SERVICE BULLETIN	
Service Bulletin #	AASB-1-12-2012
Superseded Bulletin #	AASB-1-1-2011
Issue Date	12-31-2012
Effective Date	12-31-2012
Limitations for Completion	
Make & Model Affected	Lightning LS-1 SLSA and ELSA
	SN87-133
Page 1 of

1. Applicability: Lightning LS-1 SLSA or ELSA aircraft in the effected serial range of SN87 thru SN133.

Figure 4. Fully plated section.

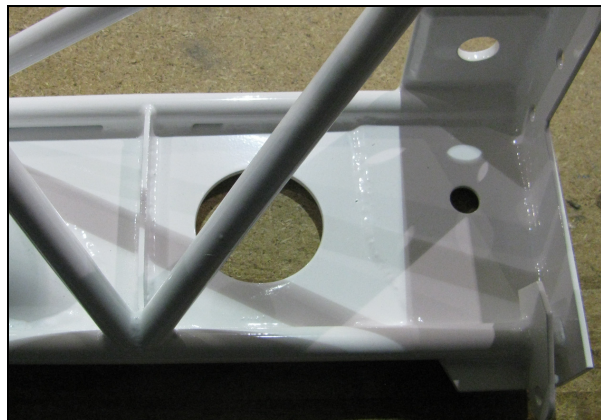
Figure 4: Overall view of current designed box with closed in section, 1 piece lower plate. Aircraft fitted with this design are not affected by this SB.

If No cracks are noted in the affected areas no immediate action is needed. The aircraft should have the plates retrofitted however. This must be done with in the next 25hrs or Annual Condition inspection. Contact Arion Aircraft For the plates needed for the retrofit.
